PLANNING COMMISSION STAFF REPORT

YWCA Building & Site Design Review

322 East 300 South

Petition #PLNPCM2010-00712

EXTERIOR ELEVATION - WEST (A4)
1/8" = 1'-0" (AE202)

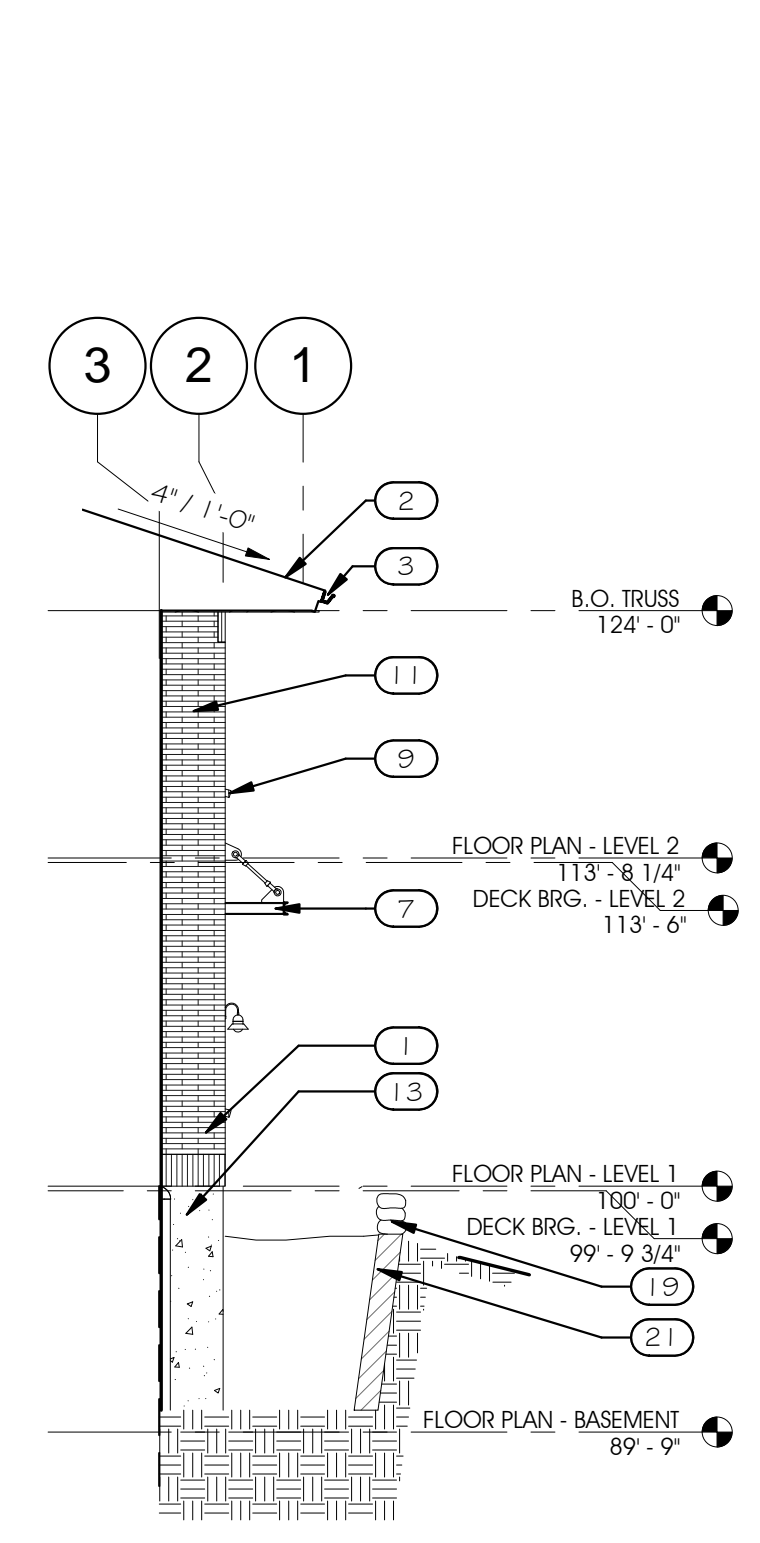
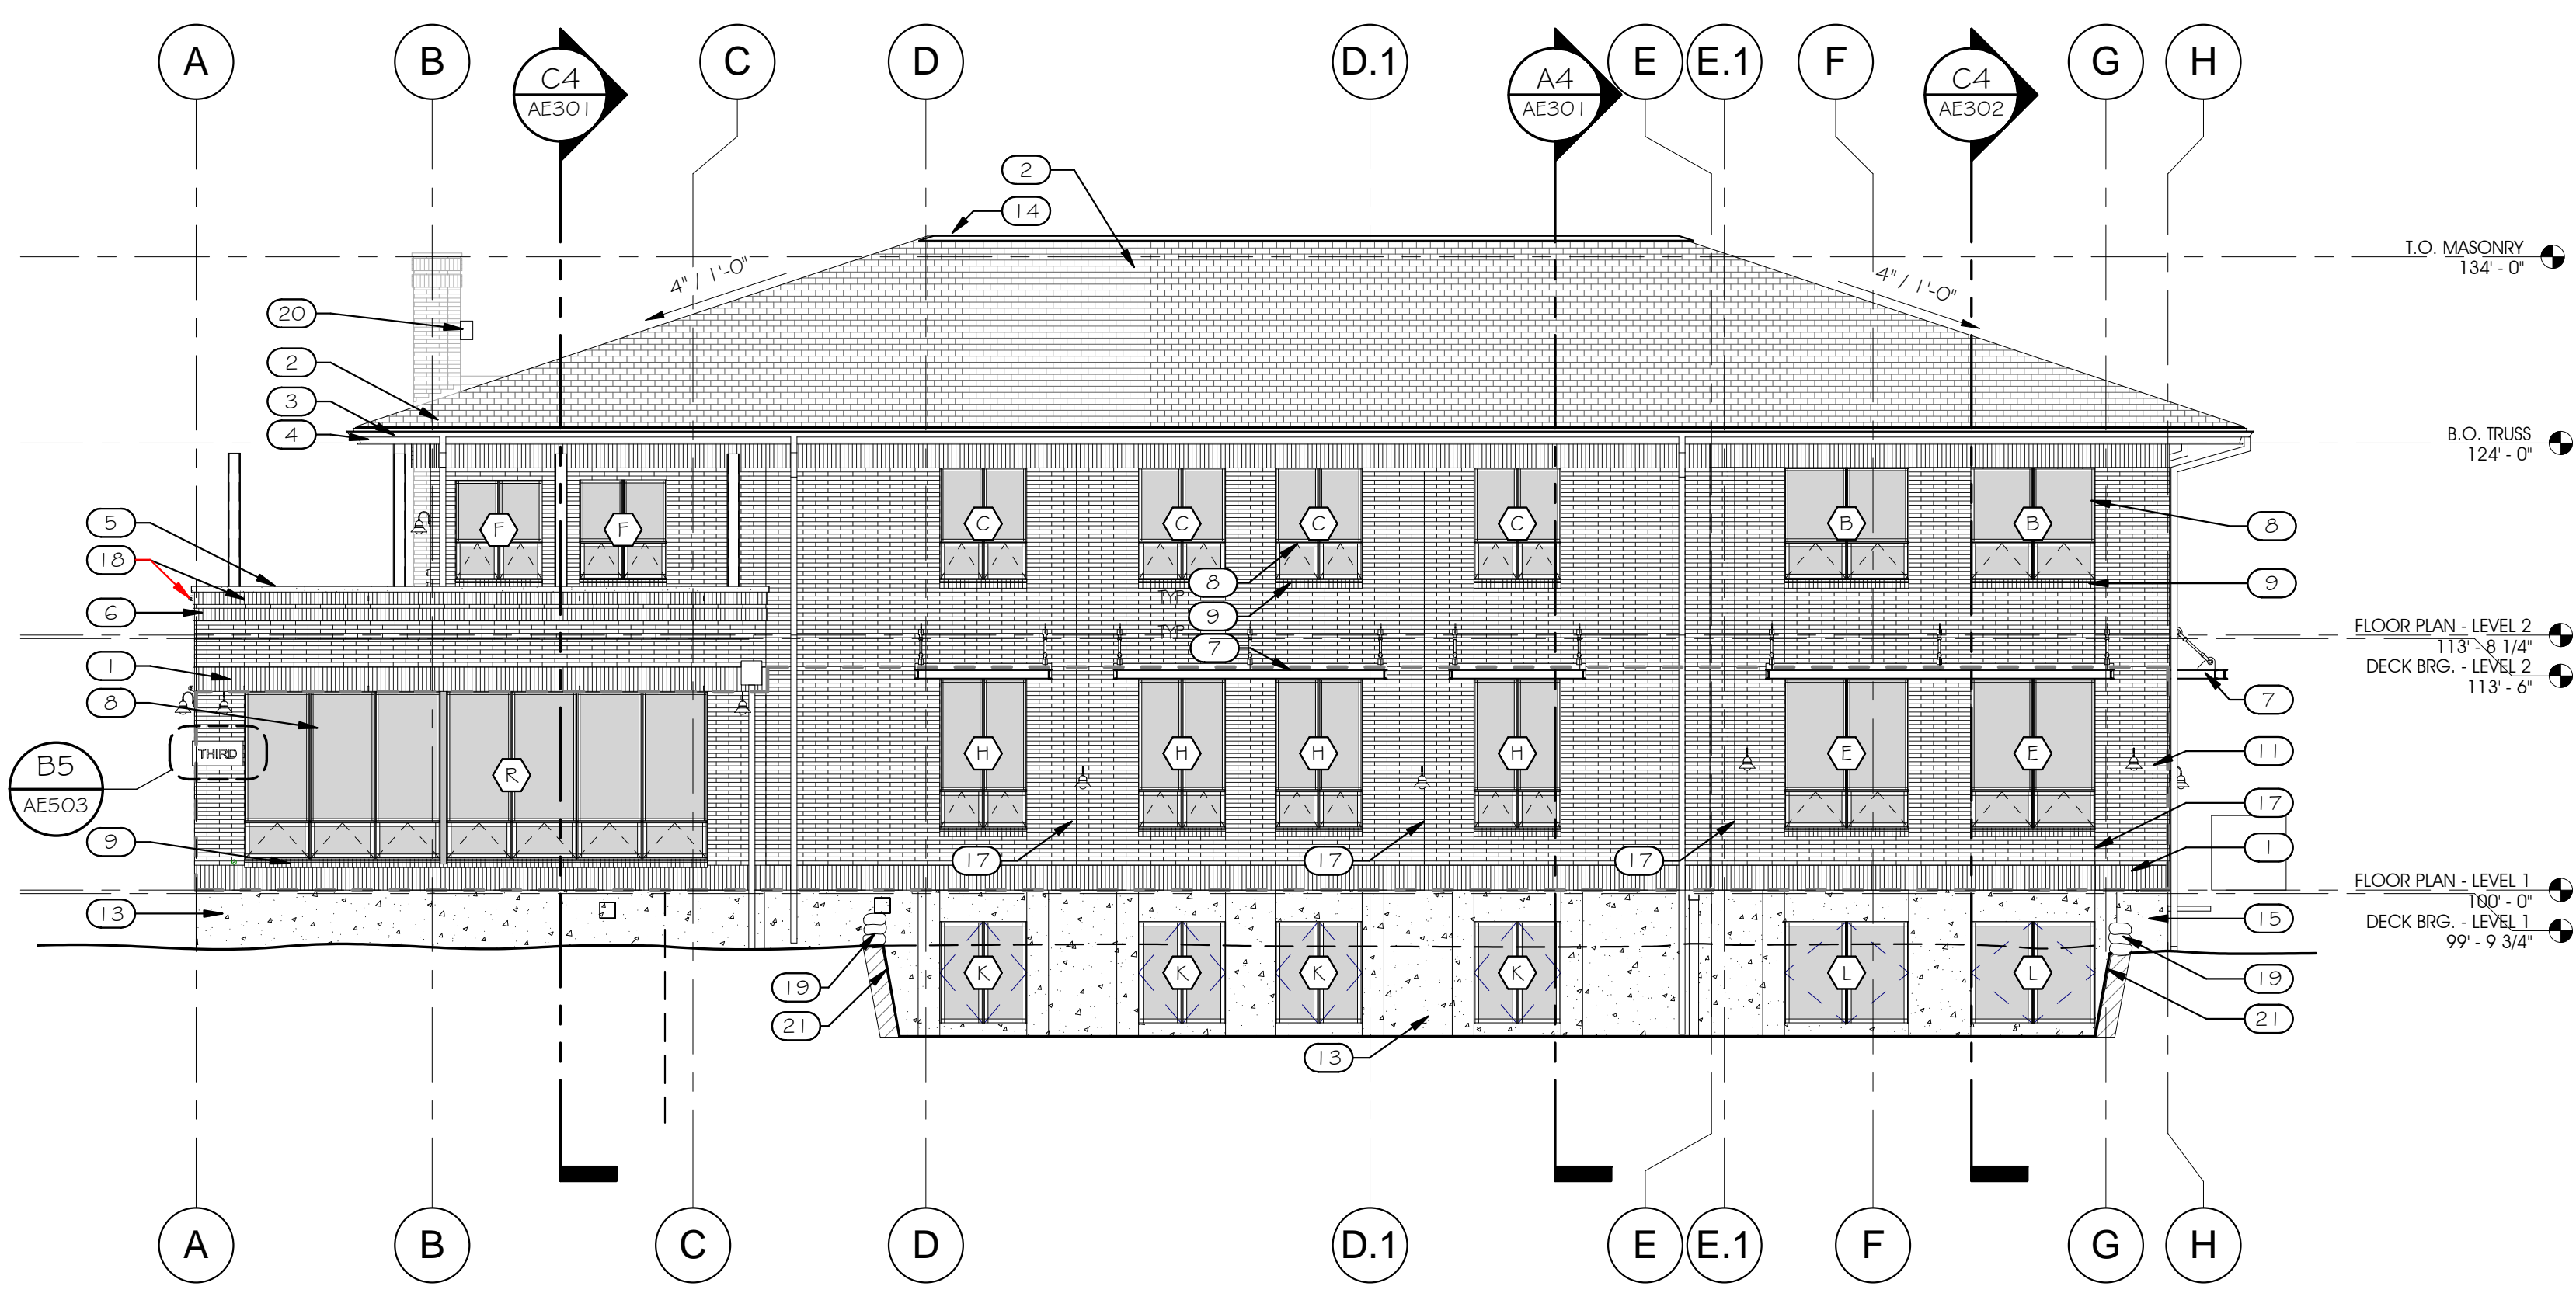
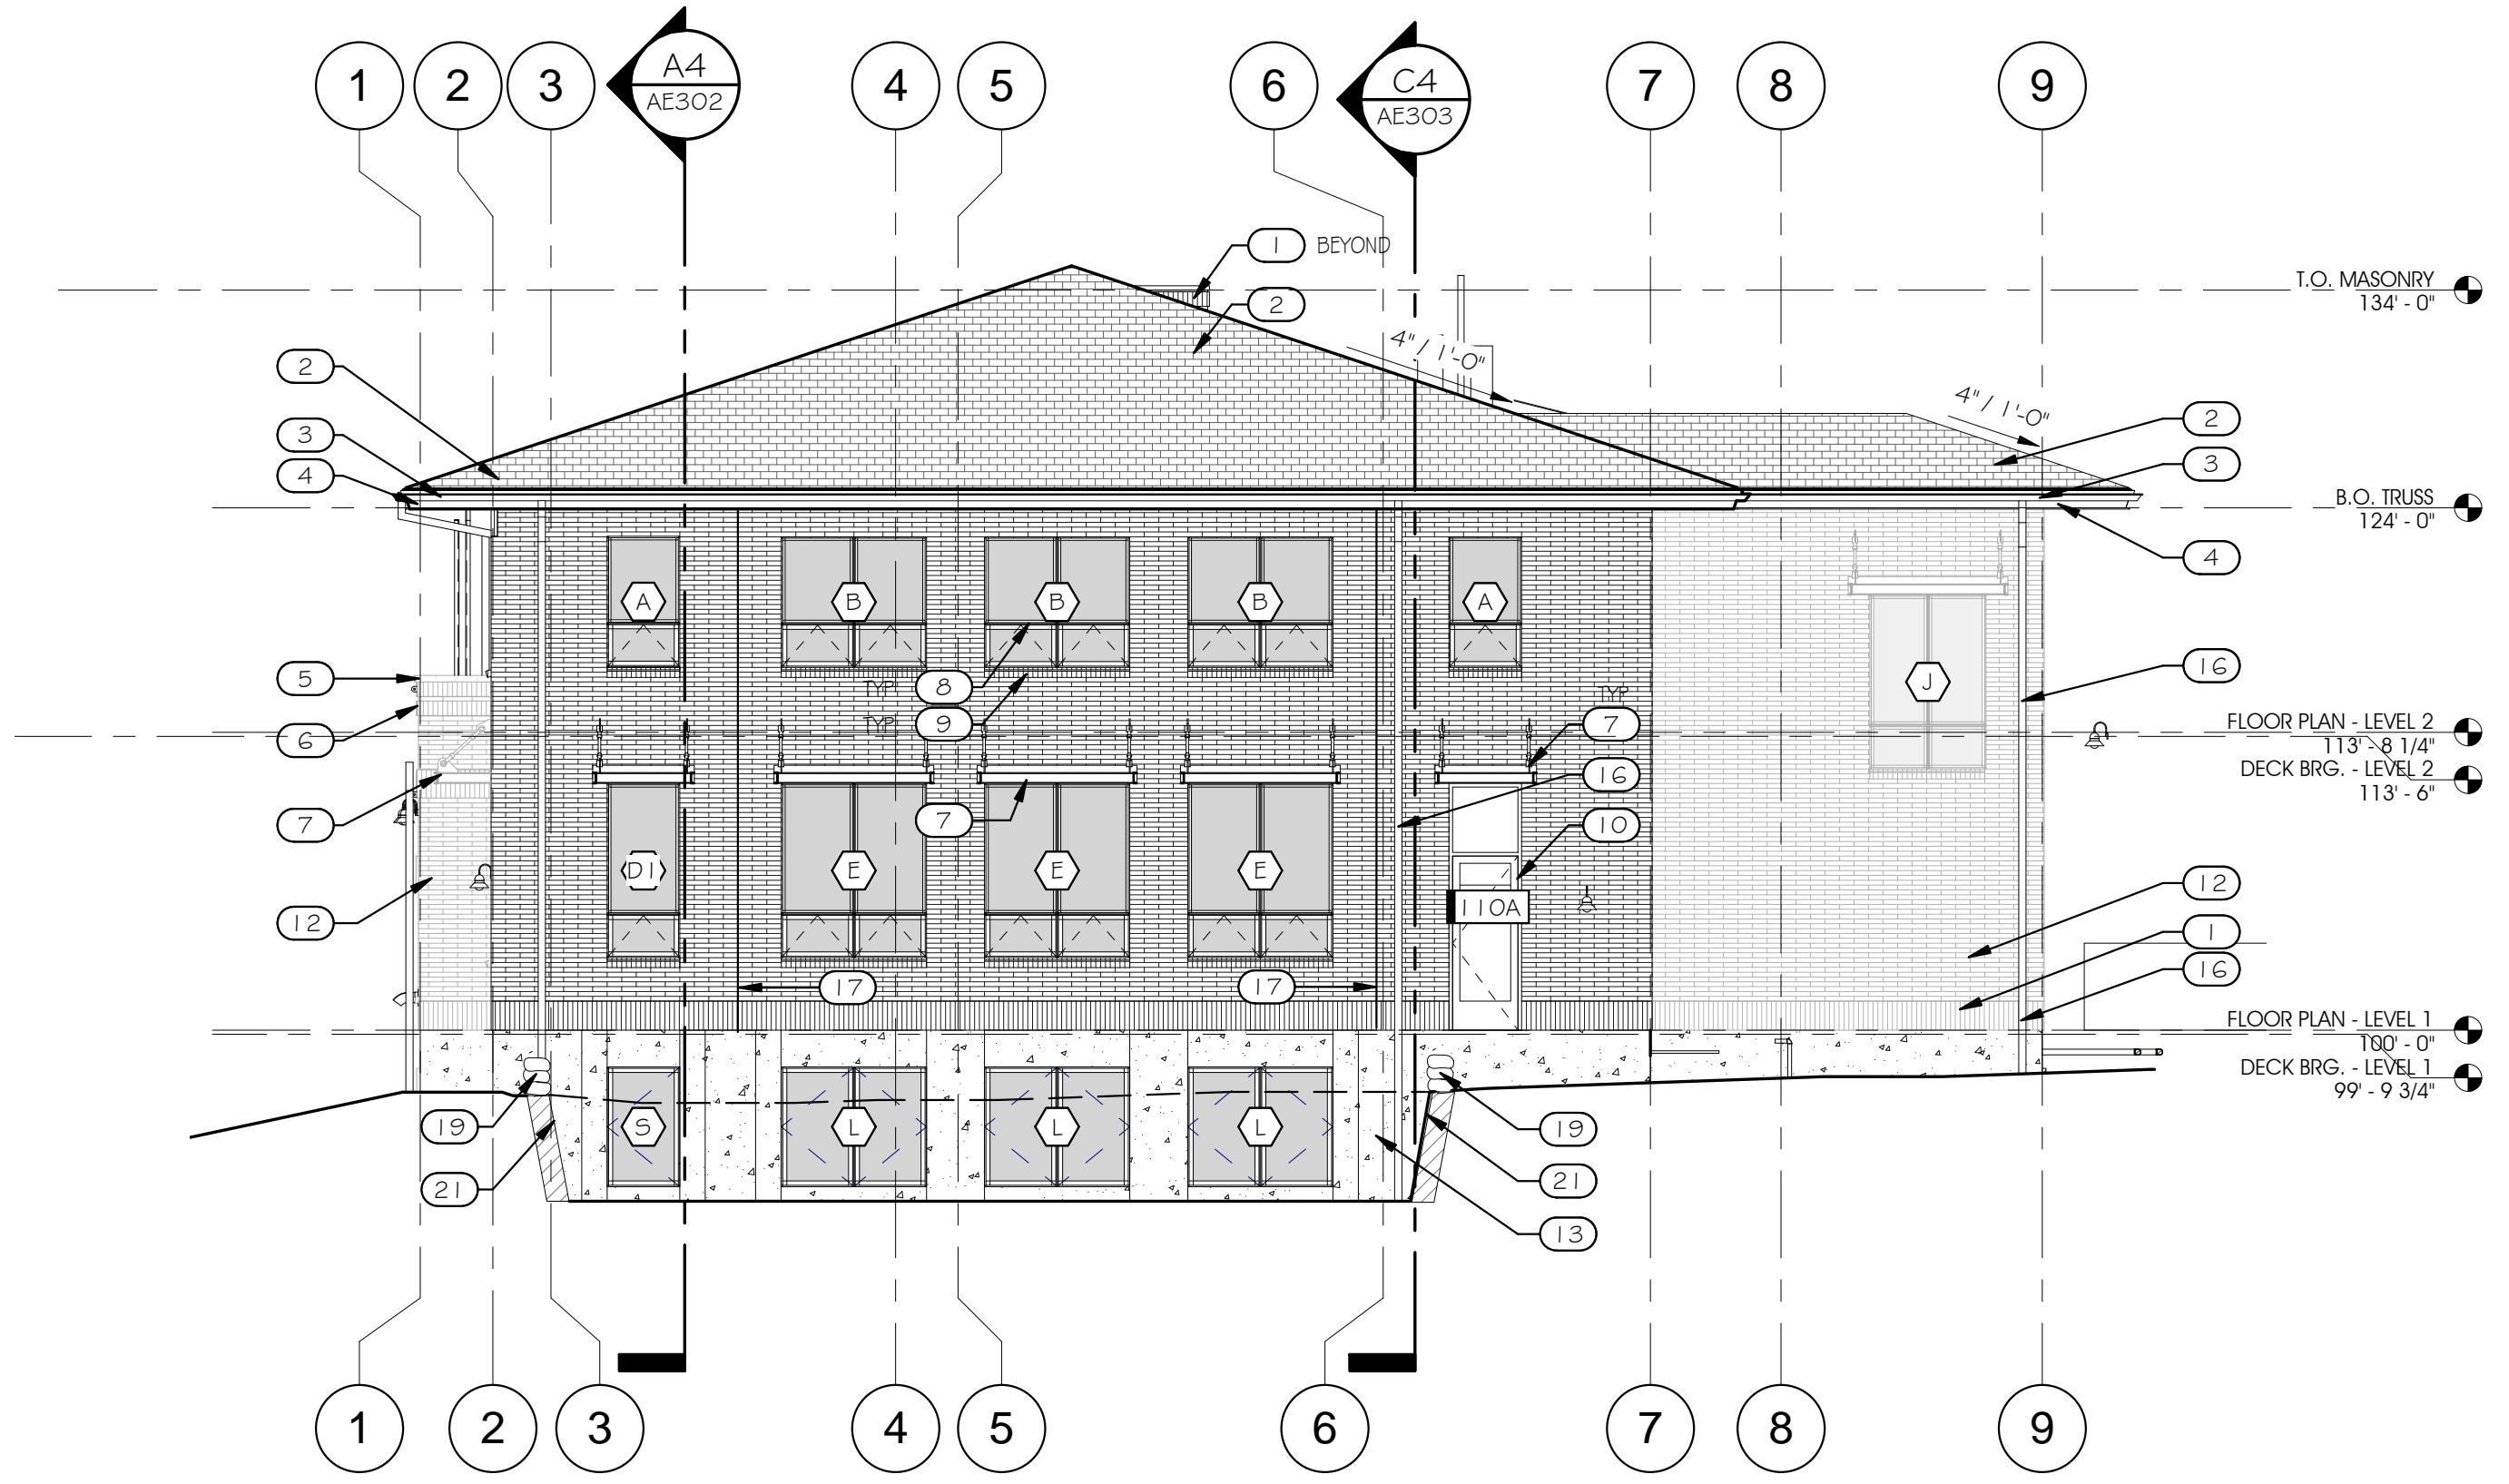
The 40 percent glazing requirement applies to both the west elevation (300 East) and the north elevation (300 South) because the proposed building has two front façades. The west elevation has 479 square feet of glazing which is 38.9 percent of the façade. The north elevation has 289 square feet of glazing, which is 36.4 percent of the façade. The glass on the first floor of both elevations is non-reflective, as required by the ordinance.

Because neither façade facing a street meets the 40 percent glass requirement, an operable door is required on both 300 South and 300 East. If both façades met the 40 percent glass requirement, a door would be required

The lack of an entrance on the west elevation is an effort to better define both the public and private spaces and foster a welcoming atmosphere to users of the YWCA services. It also aids in the security of the building by reducing the number of access points.
